Annex 1 – Original Proposal and New Proposal

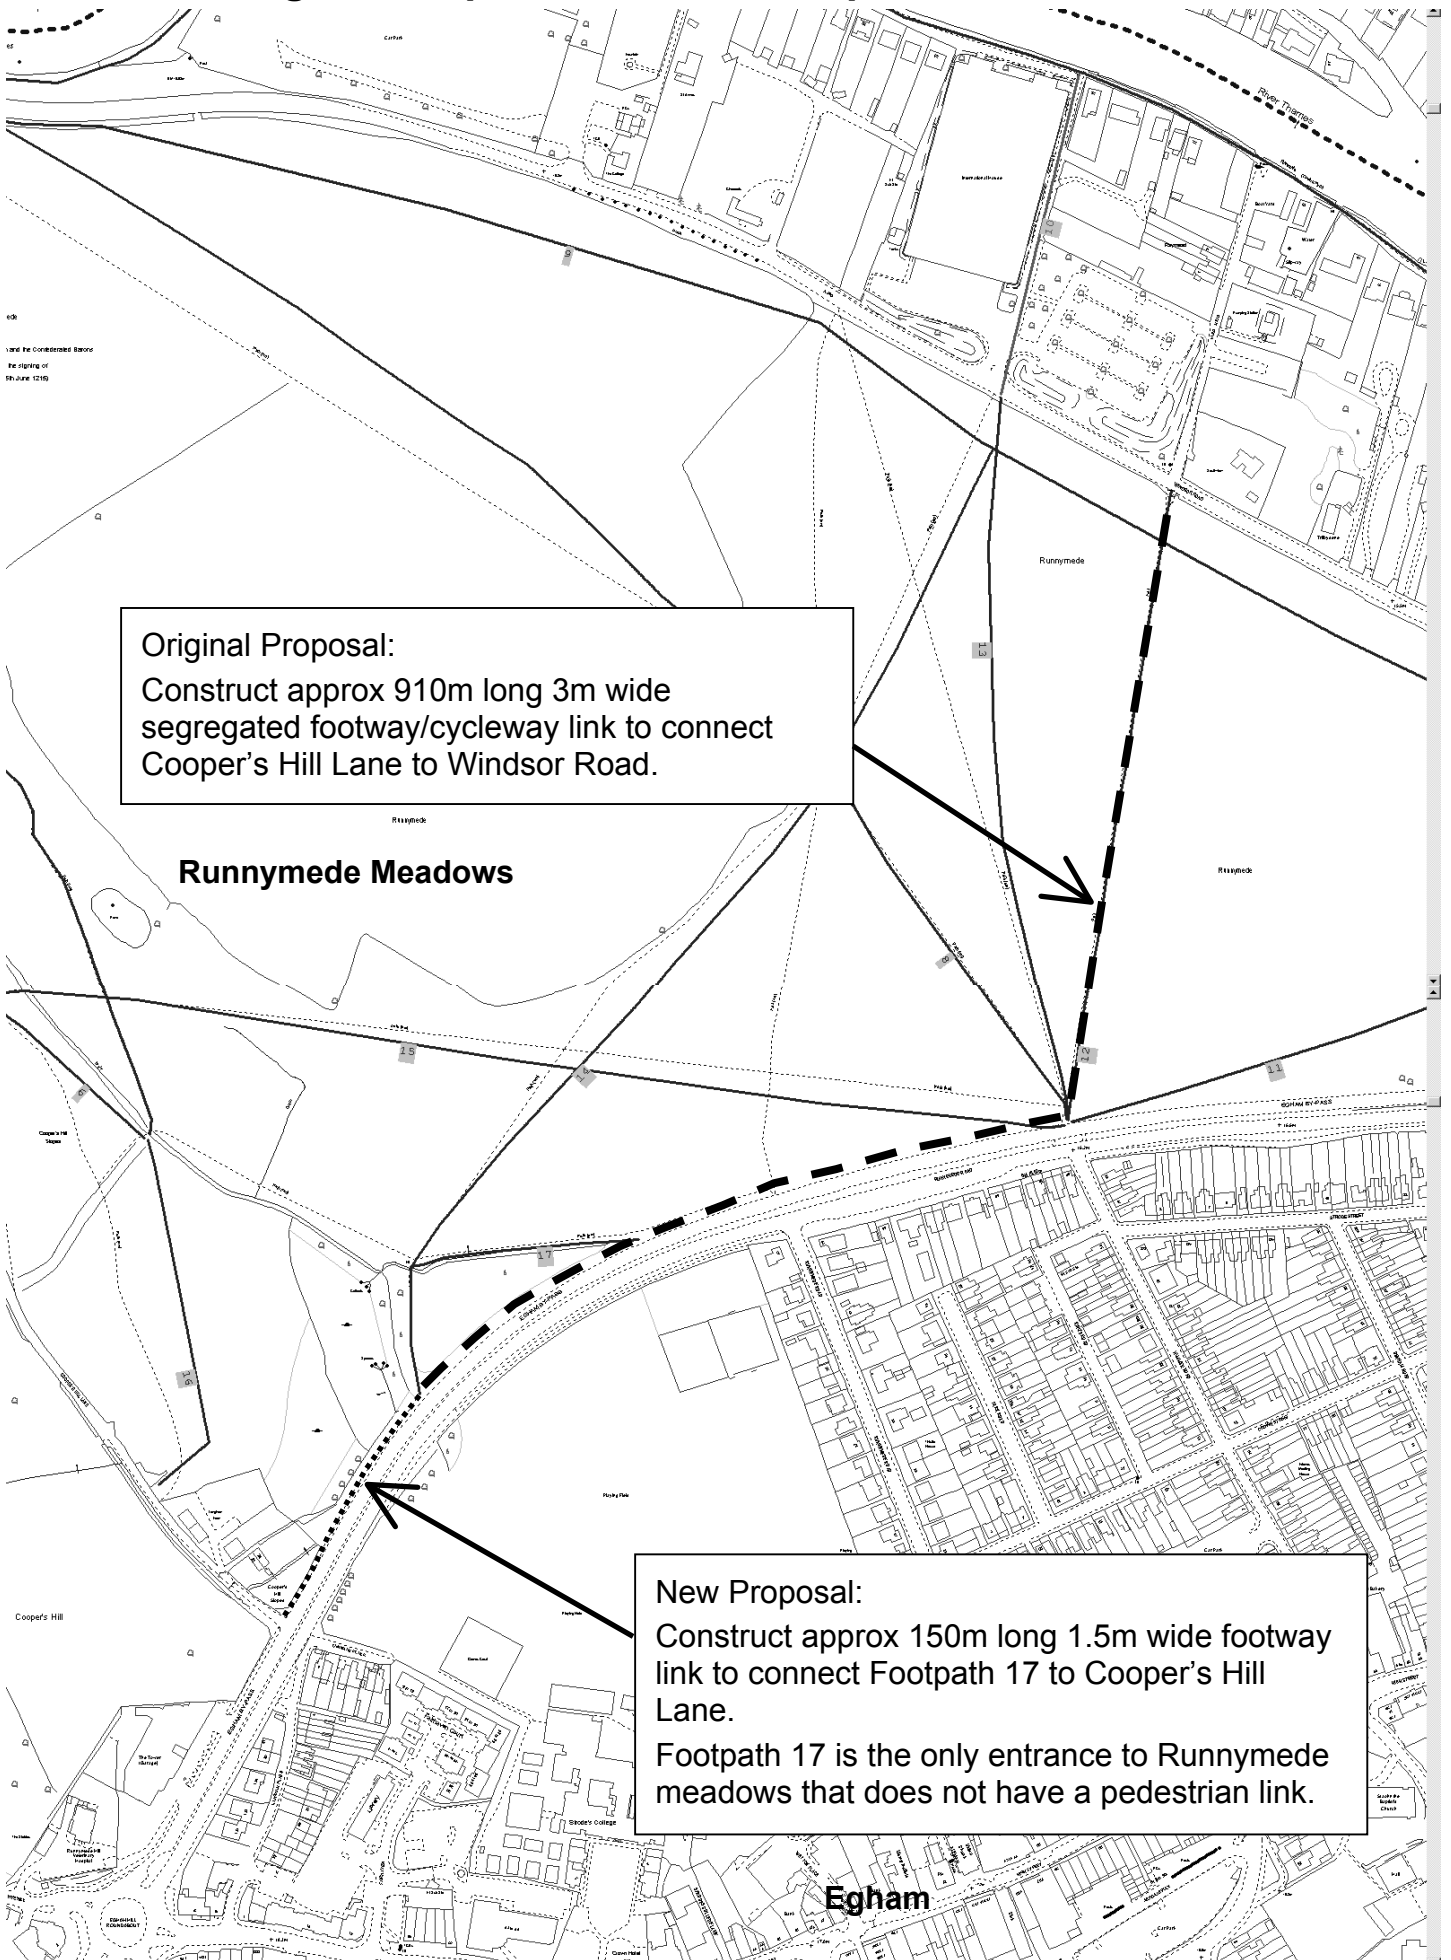
Original Proposal:
Construct approx 910m long 3m wide segregated footway/cycleway link to connect Cooper's Hill Lane to Windsor Road.

New Proposal:
Construct approx 150m long 1.5m wide footway link to connect Footpath 17 to Cooper's Hill Lane.
Footpath 17 is the only entrance to Runnymede meadows that does not have a pedestrian link.
